DATE:	July 1, 2025
MAI NO.:	24001
DSA APPL. NO.:	02-122658
DSA FILE NO.:	10-28
PTN:	62125-41

**NEW CLASSROOM WING AT
SUNSET ELEMENTARY SCHOOL
COALINGA-HURON UNIFIED SCHOOL DISTRICT
COALINGA, KINGS COUNTY, CALIFORNIA**

ADDENDUM NO. 3

C3.1_ADD3

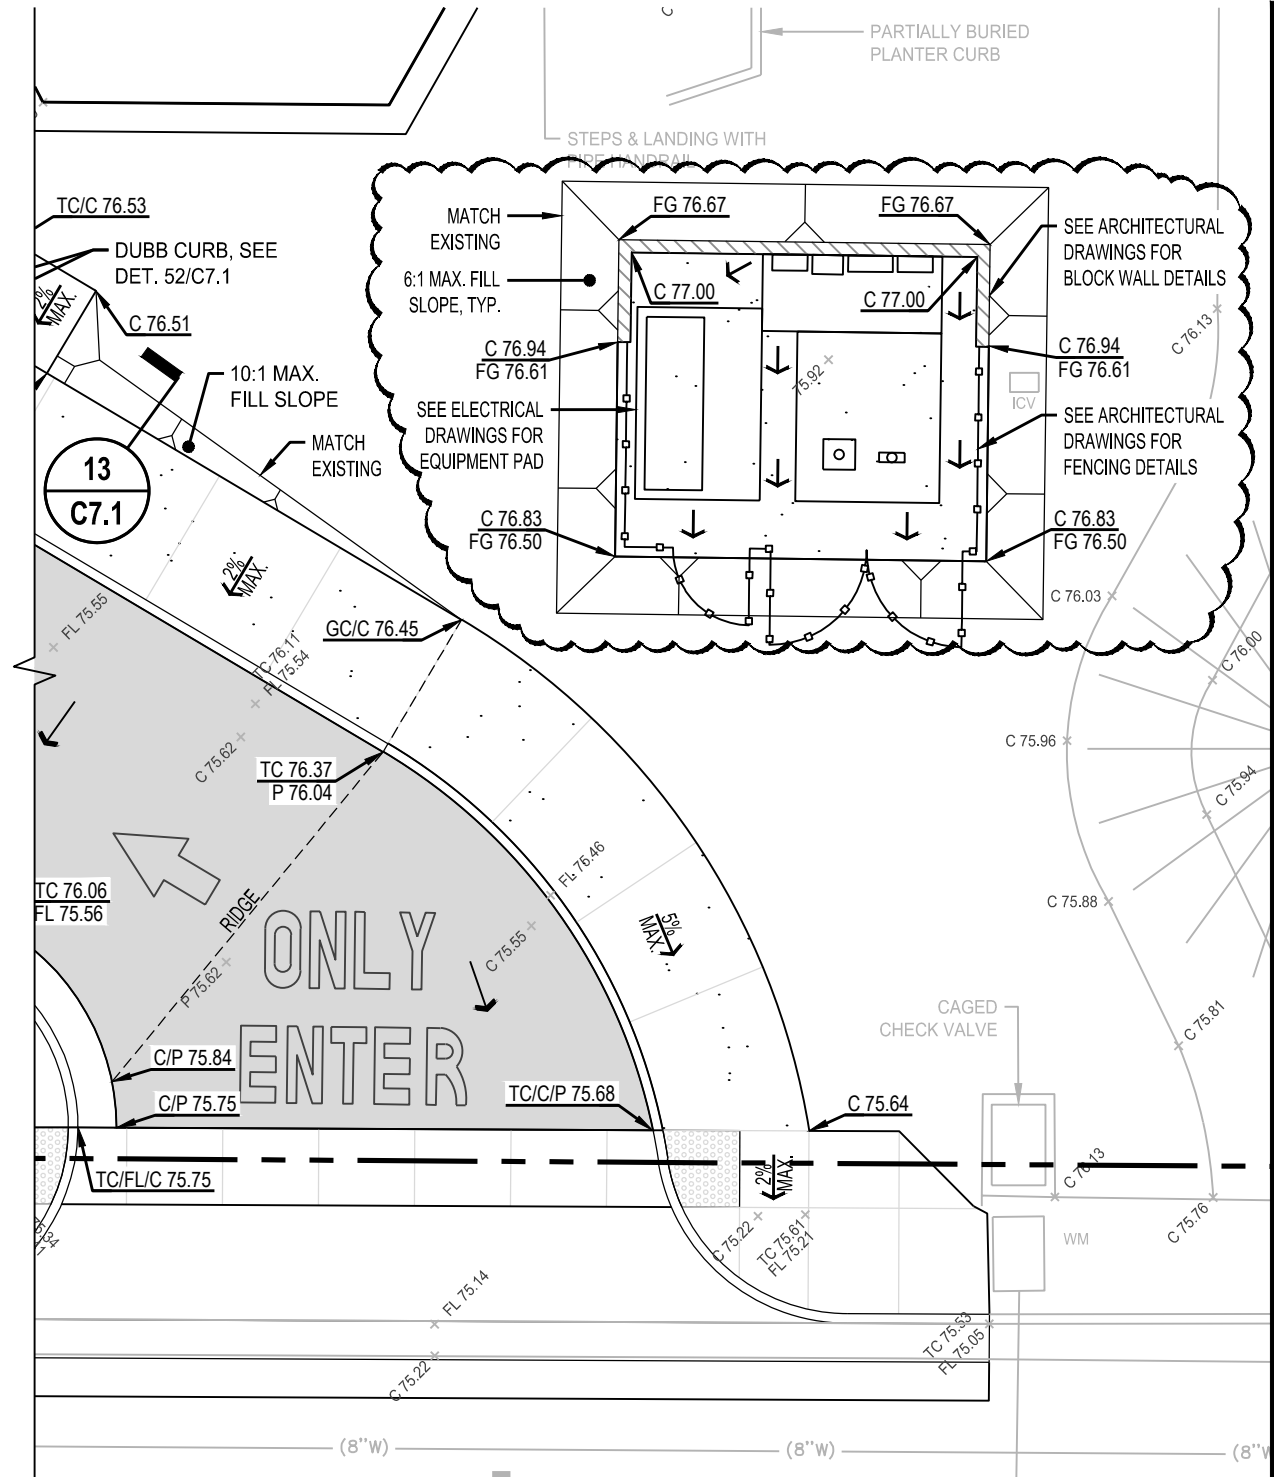
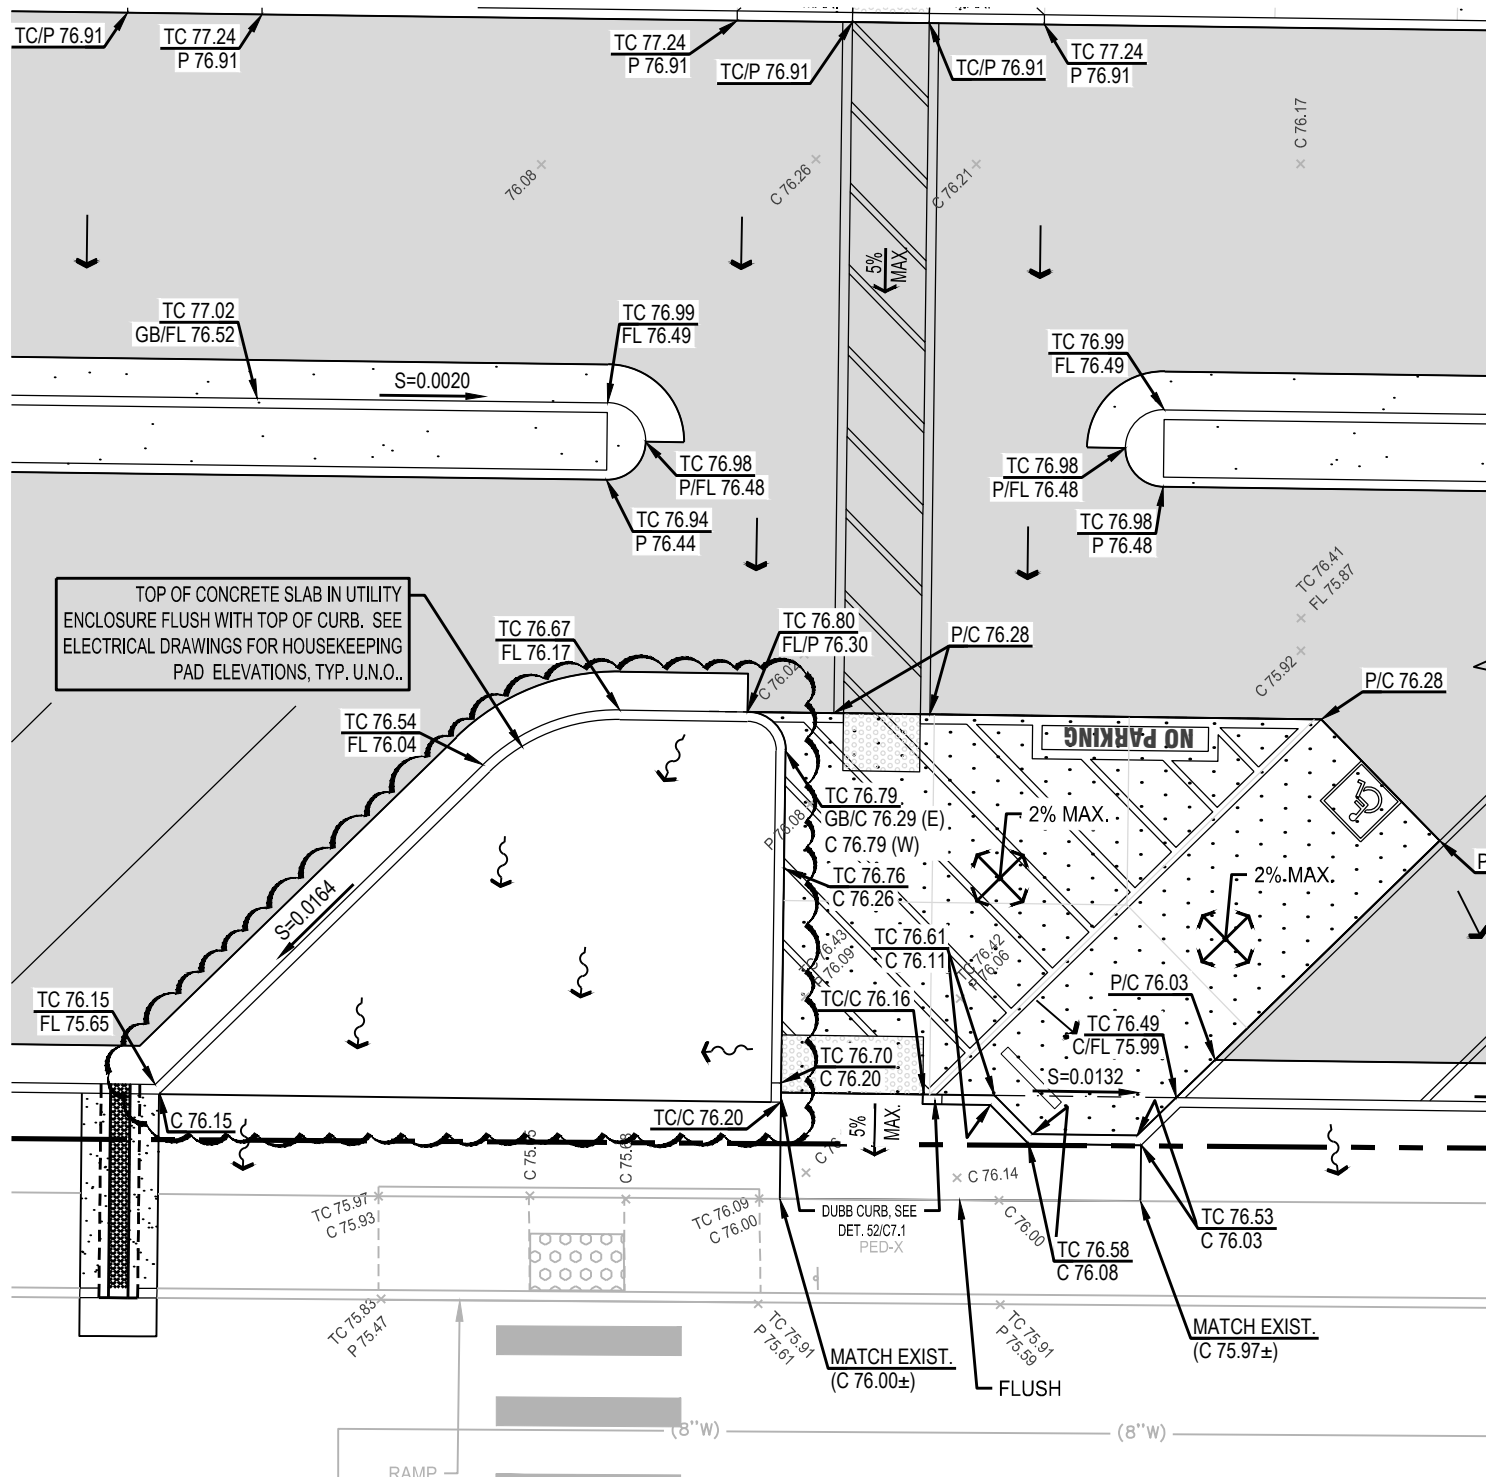
The grading plan has been revised due to the electrical enclosure being relocated to the east. New grades have been added to the new enclosure location, while the old location will now be landscaping. Both areas with changes are clouded on the attached sheet **C3.1_ADD3**.

LA1
ADD-03

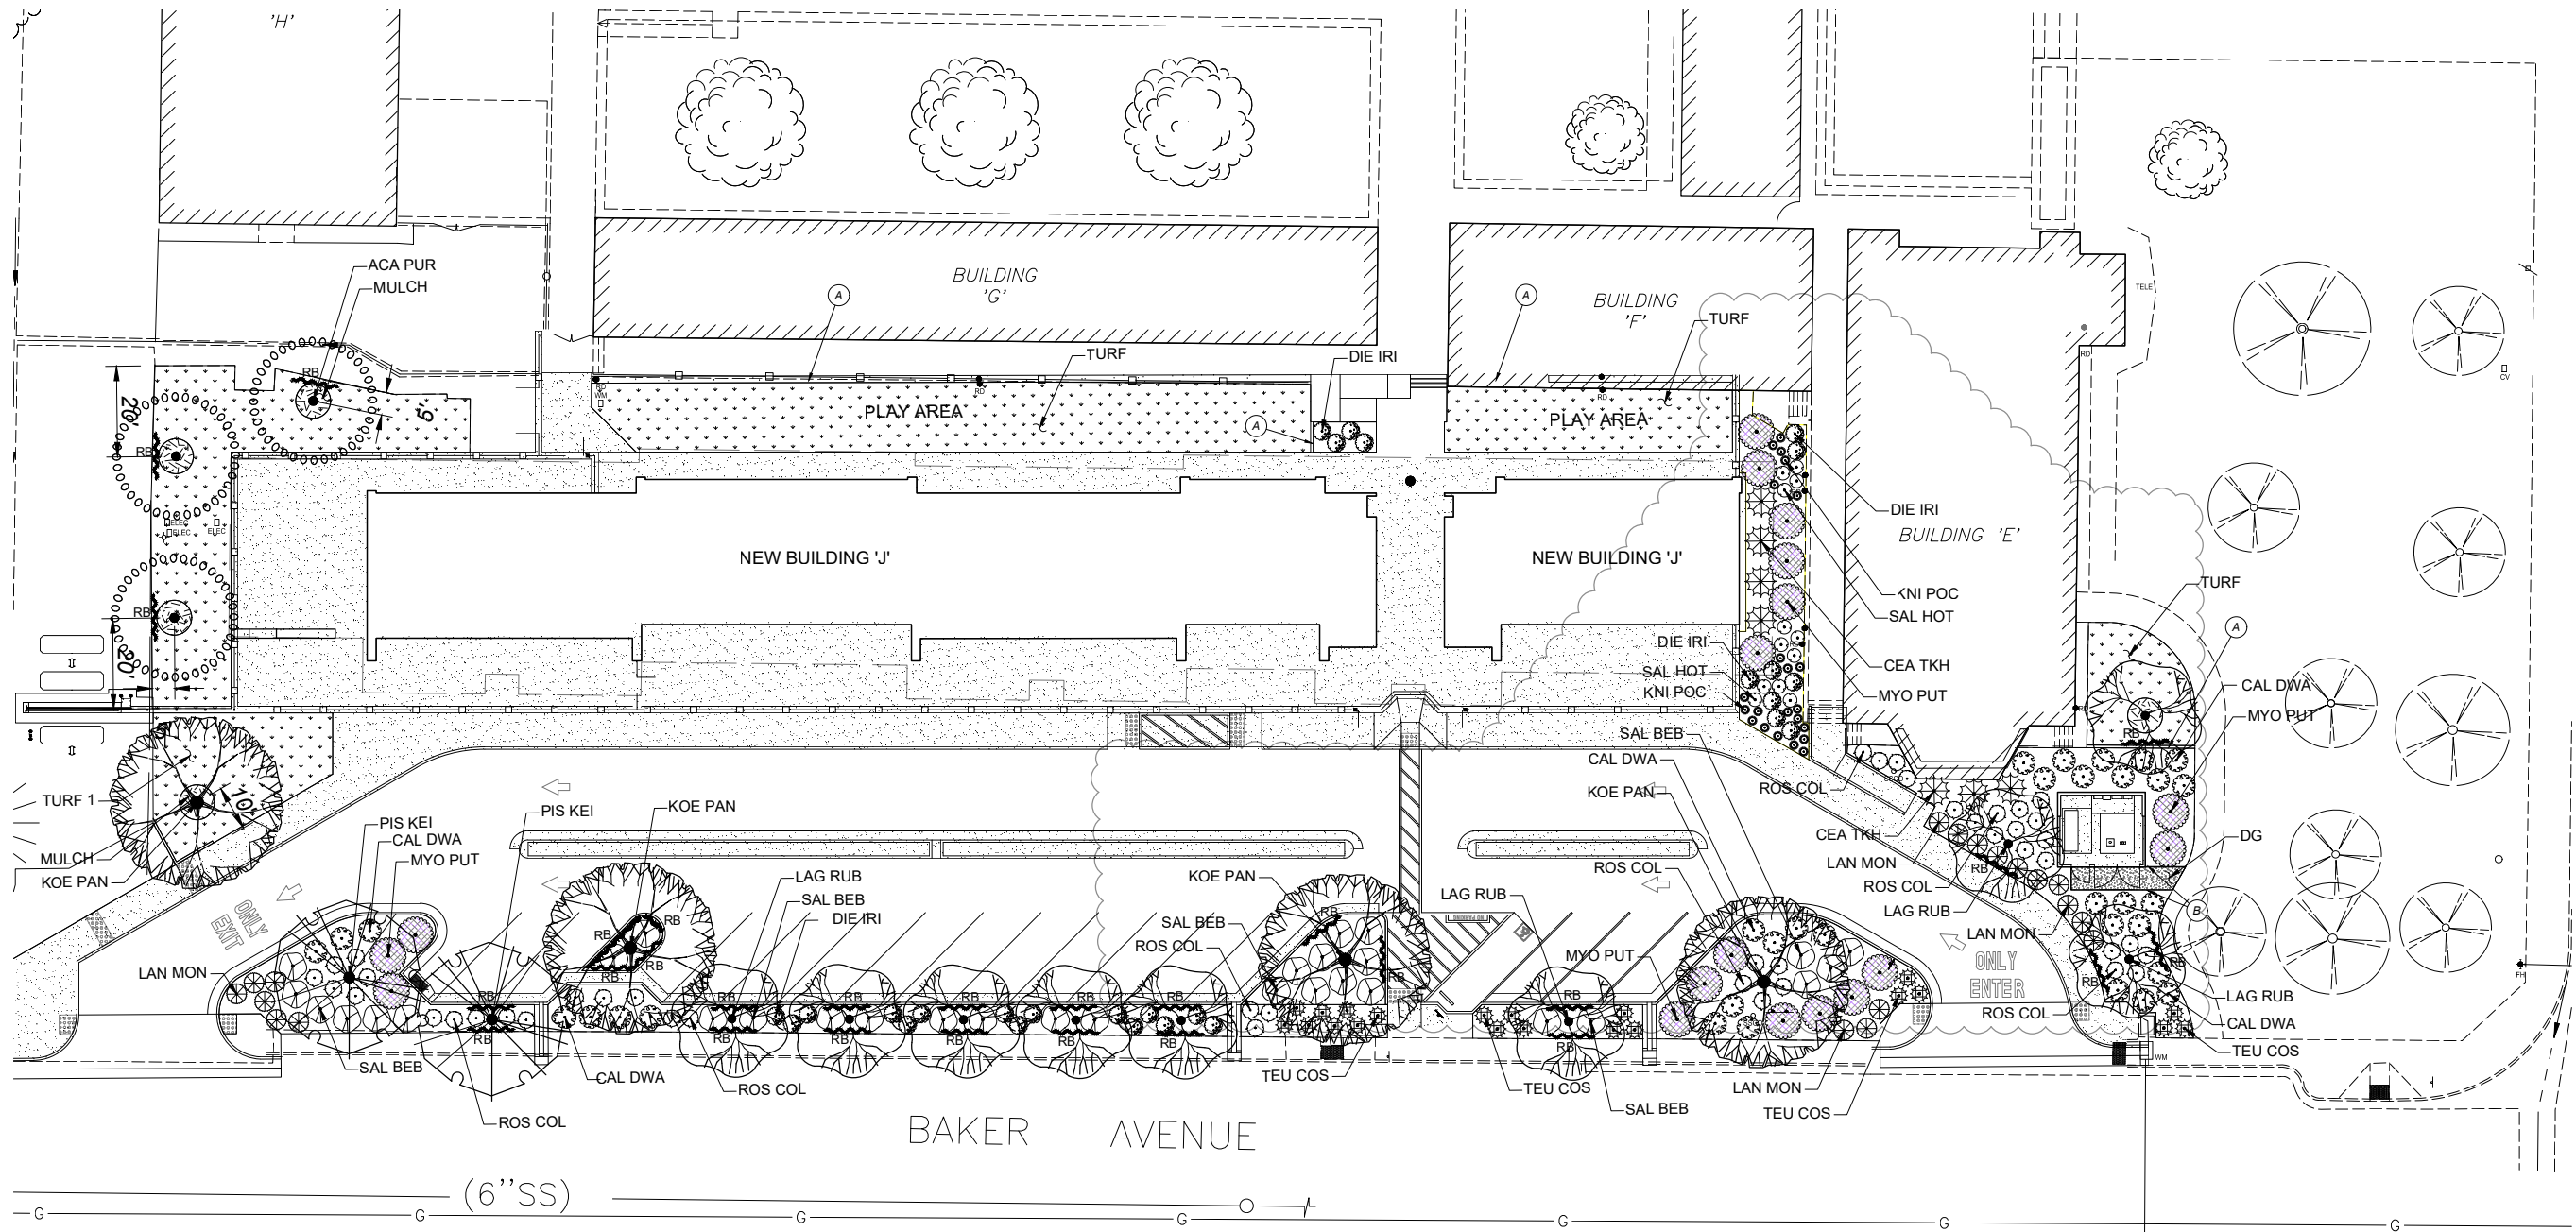
Revise sheet as shown on attached sheet LA1 ADD-03 clouded changes.

LA3
ADD-03

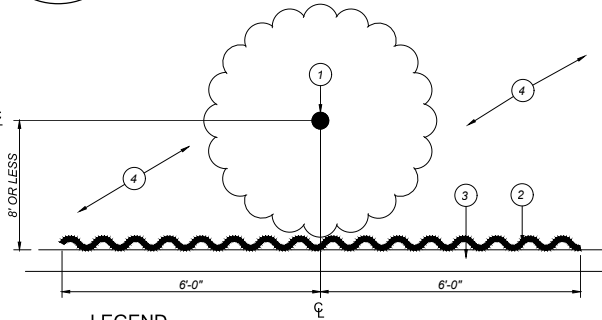
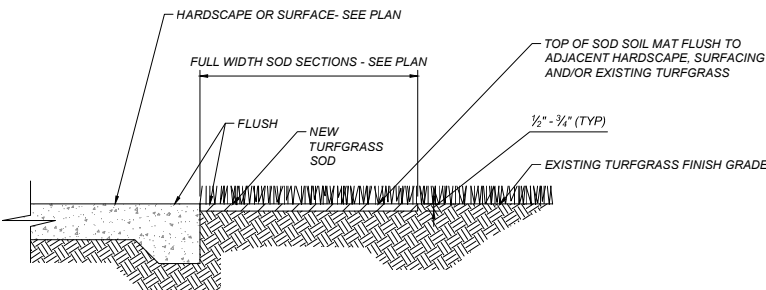
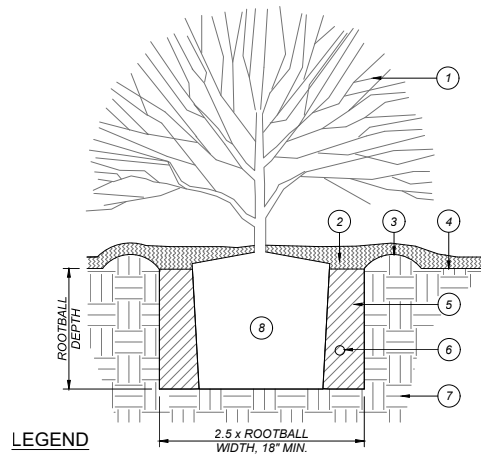
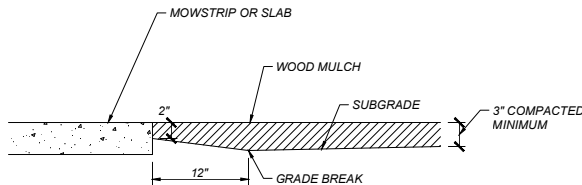
Revise sheet as shown on attached sheet LA3 ADD-03 clouded changes.

IR2
ADD-03

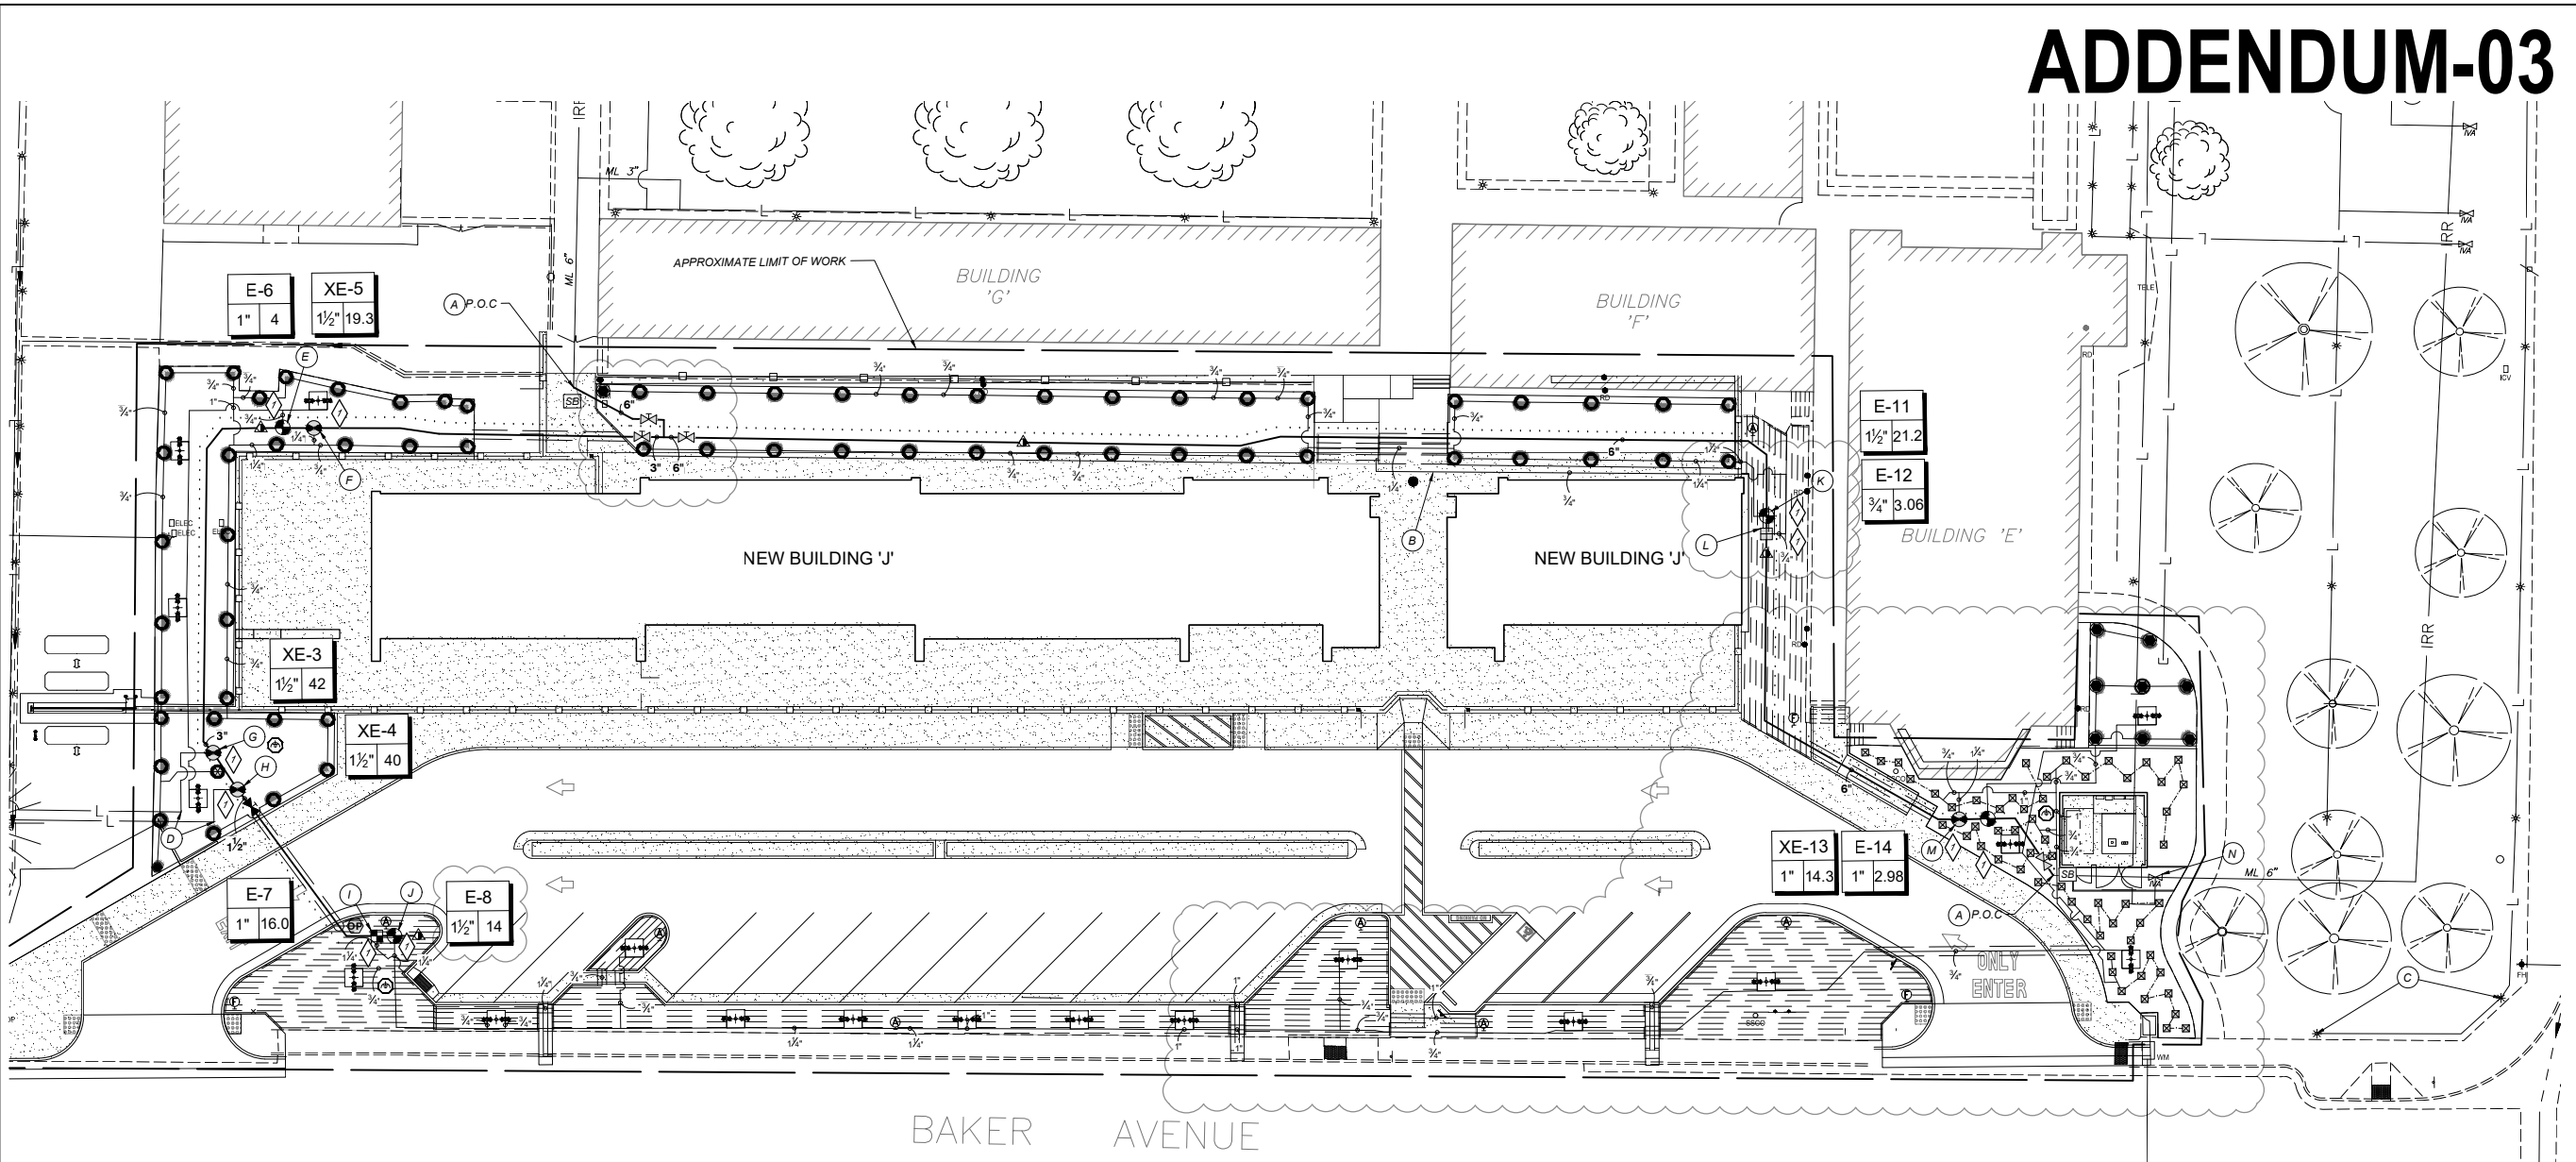
Revise sheet as shown on attached sheet IR2 ADD-03 Irrigation Plan clouded changes.

Revise sheet as shown on attached sheet IR2 ADD-03 Irrigation Legend clouded changes.
